Access Compliance Report

| Intersection ID: 3576 | Main Street: EVERCLEAR_CT | Cross Street: PRESERVATION_POINTE_DR | Location: NW |
| ADA ID: C0218D7254B8 | Ramp Type: Perp | Initial Pass/Fail: Fail | Overall Compliance: No |

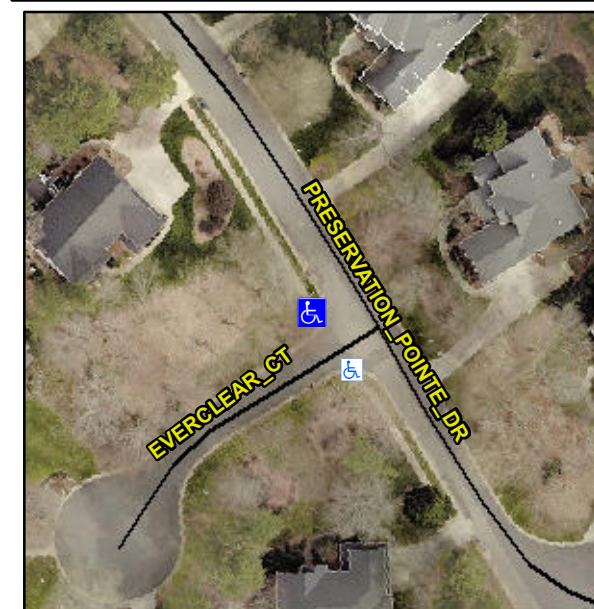
R304.2.2

| Compliance | Description | Data | Compliance | Description | Data |
|------------|-----------------------|-------|------------|-----------------------------|------|
| N/A | Ramp Length (in) | 49.0 | No | Ramp Slope (%) | 8.5 |

Remove & Replace Entire Ramp.
